Re: Planning Proposal (PP 2020/1/1)

5 Smalls Road, Grasmere

Lot 201 DP 734620

We again object to this Planning Proposal (PP) for seniors' housing at 5 Smalls Road located in rural Grasmere. Our reasons for objection remain largely unchanged from those in our submissions dated 22 April 2022 and 8 October 2020. These are appended for inclusion with this submission to reduce repetitiveness of detail. We acknowledge the private sector's role in providing much needed seniors' housing, particularly given Australia's aging population. From a community perspective, it is all about how and where it is developed, what is lost, whether it accommodates aging in place and looking beyond the profit motive.

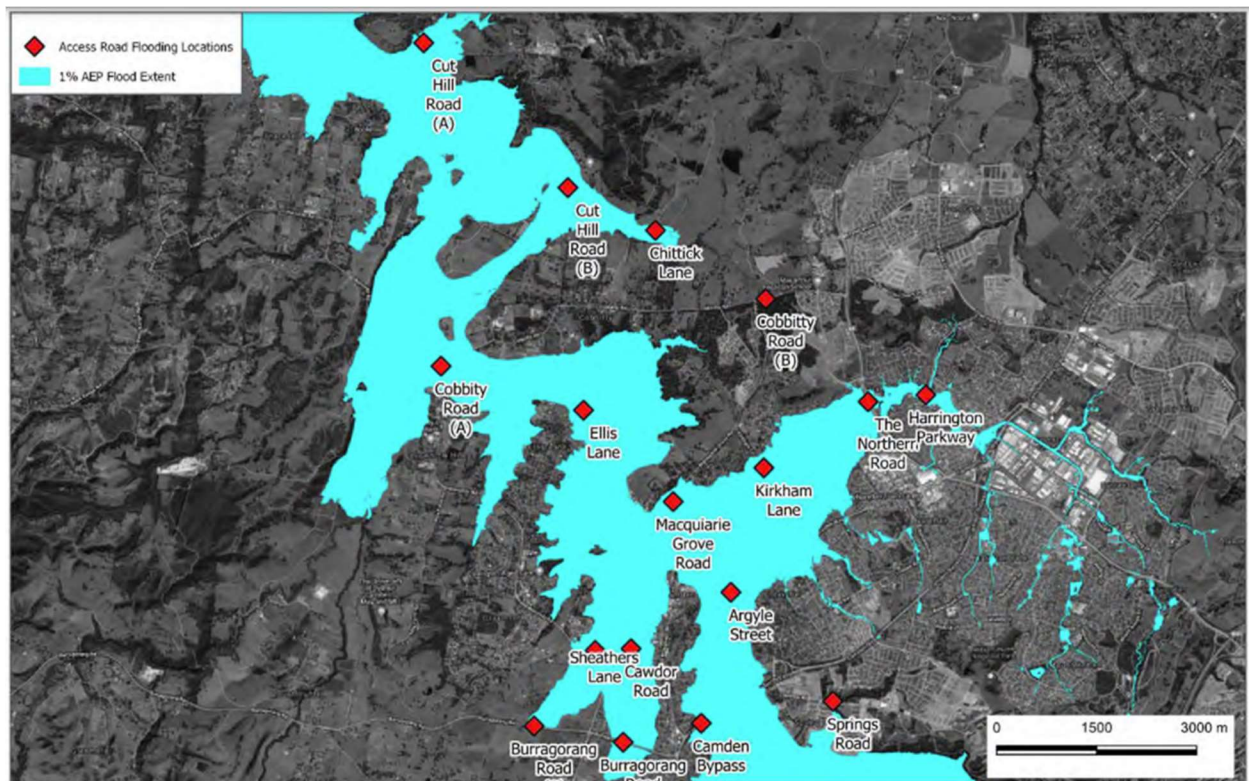
The analysis in the FRMSP clearly shows the problem of flooding of access roads to the site. It is also likely that the density of the proposed development would increase run-off and exacerbate water depths and the well-known local drainage problems.

The FRSMP (10.3.1) states that *access is considered lost when depths exceed 0.2m and that the following table highlights a key flooding issue... Due to the relatively large flood depths that occur in even minor events, many roads experience loss of access in the 20% AEP event, with overtopping depths ranging from 0.1 m to 2.8 m. Camden Bypass is the only crossing that is accessible for up to the PMF event.*

Figure 2: Heights of buildings

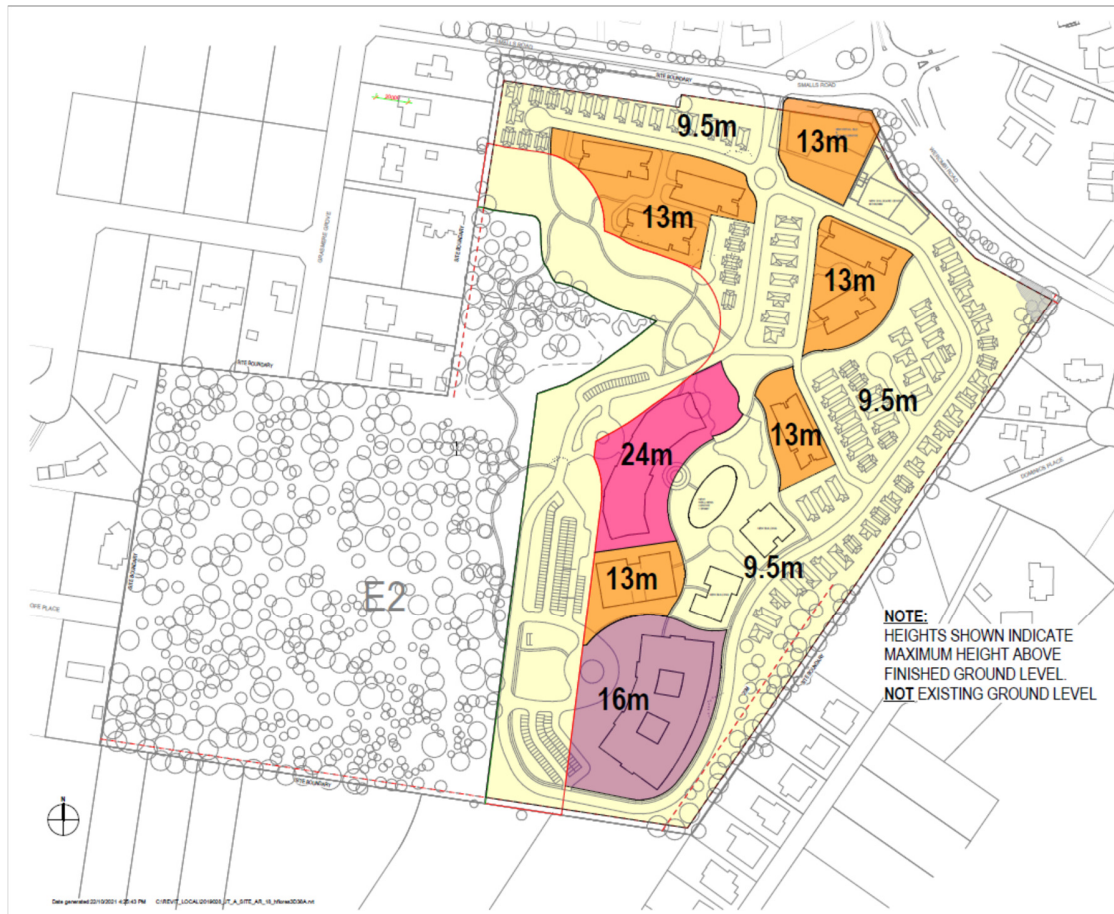
A comparison shows a main change in the north of the site with the replacing of large over-height buildings, except for the 13m building at the roundabout, with many smaller ones at 9.5m.

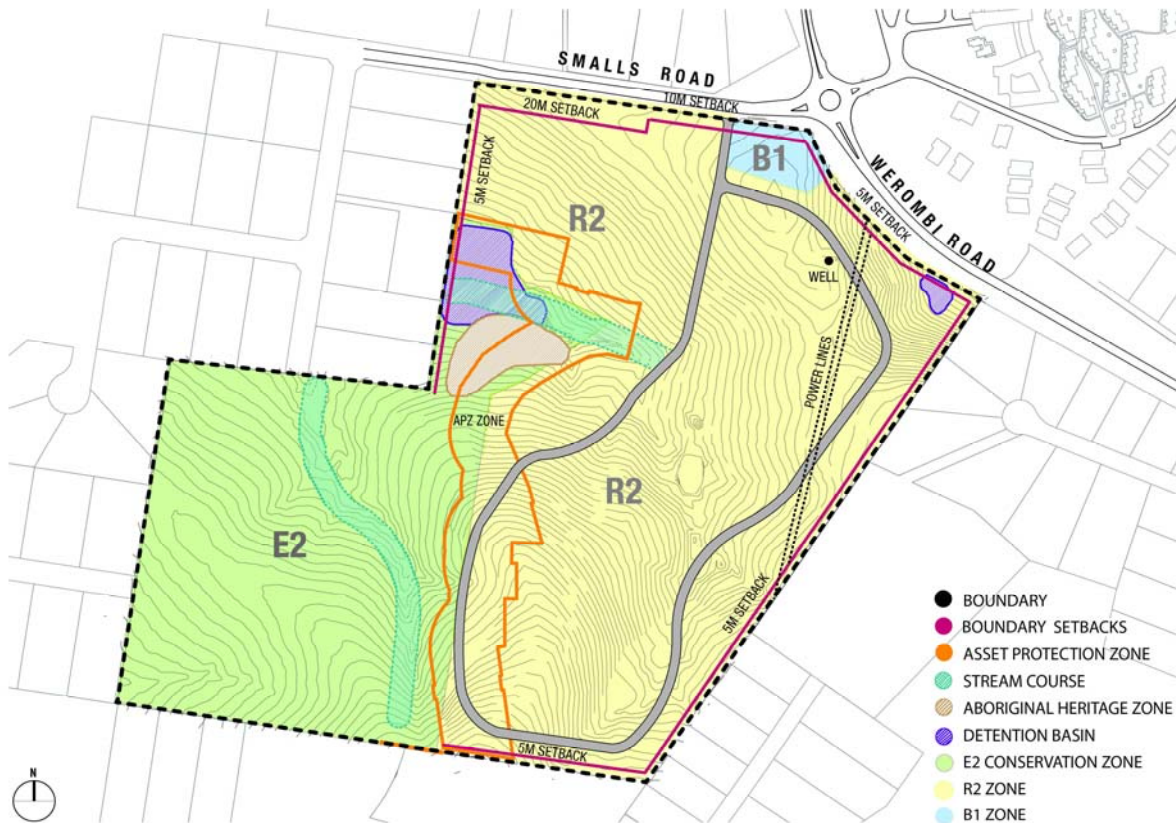
How is all of the Critically Endangered CPW identified in the *Draft Cumberland Plain Conservation Plan* to be conserved or at least offset?

What is the impact on CPW conservation of APZ being within the E2 zone?

If the APZ is to fall within E2, how can fuel reduction involving removal of vegetation be ensured to be compatible with conservation of critically endangered species?

1 RECREATION CENTRE & PREMIUM ILU8 - LONG SECTION
SCALE 1:200

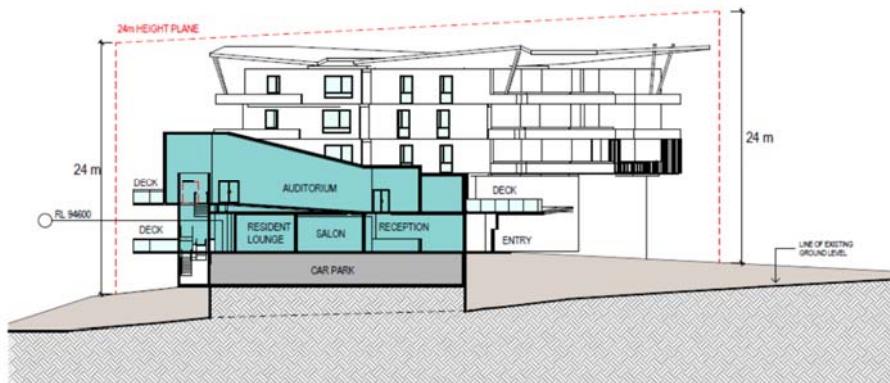
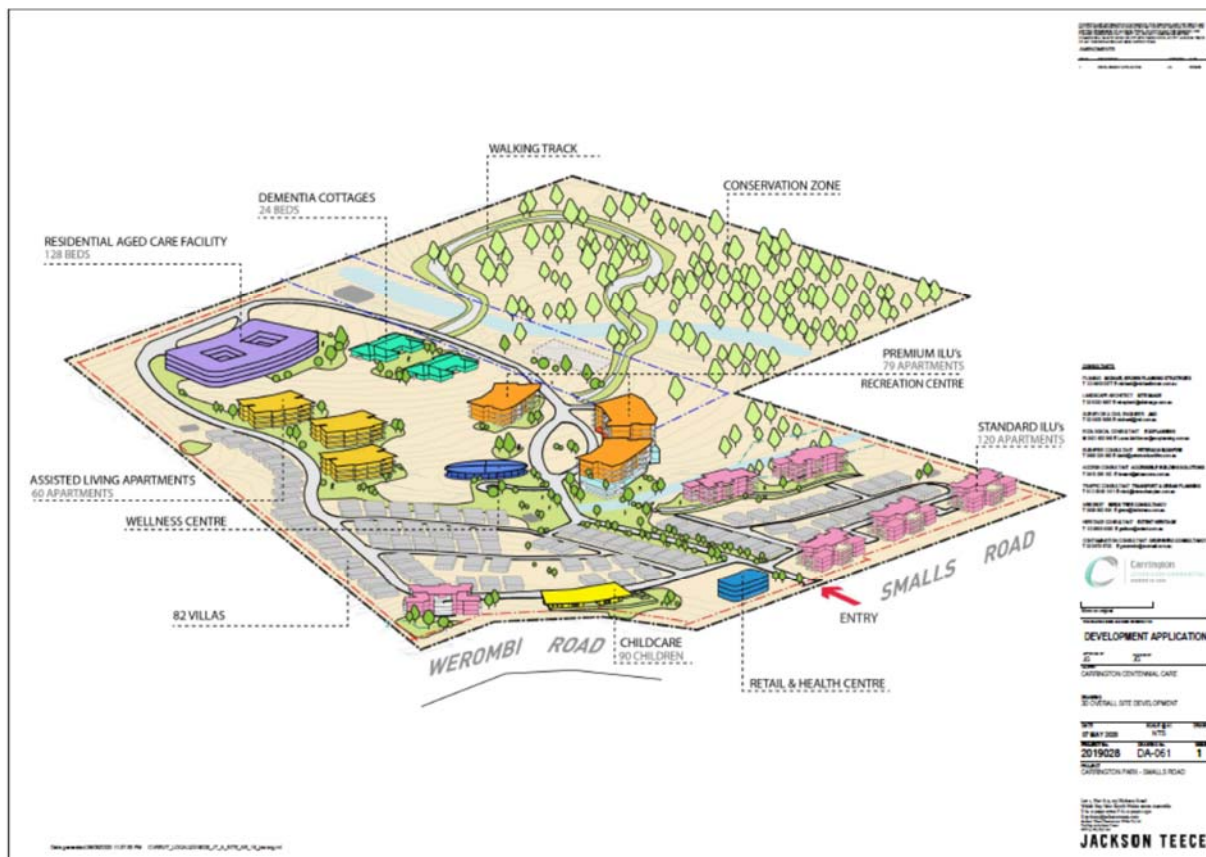
The Architectural Public Plans show maximum height relating to 24m as above finished ground level, not existing ground level, and the publicly available architectural diagrams, some of which are included below, clearly demonstrate the impact of building height and number of stories.
